ROTAX ULTRALIGHT ENGINE TYPE 503 FREE AIR (FA)

1) GENERAL

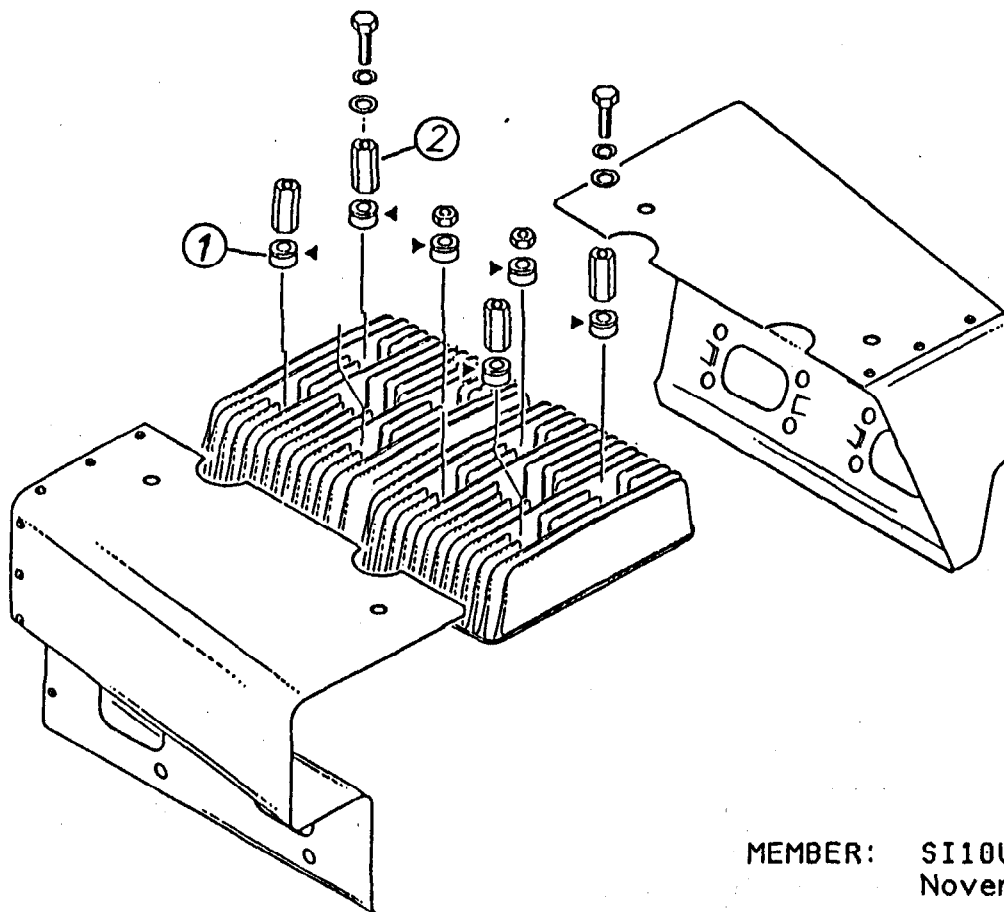
1.1. In the course of further development the cylinder head fixation of engine type 503 UL FA has been modified. This modification is to reduce the stress concentration of cylinder studs and to avoid occasionally experienced breaking of the studs.

2.1. All 8 shims 8,4 are replaced by 4 mm high cone sleeves (1), part no. 847 475.

The cone sleeve has to be fitted with the cone side on top (for recognition marked by a groove, see illustration).

2.2. 4 distance nuts M8 x 37 are replaced by 4 distance nuts (2) M8 x 33, part no. 242 660.
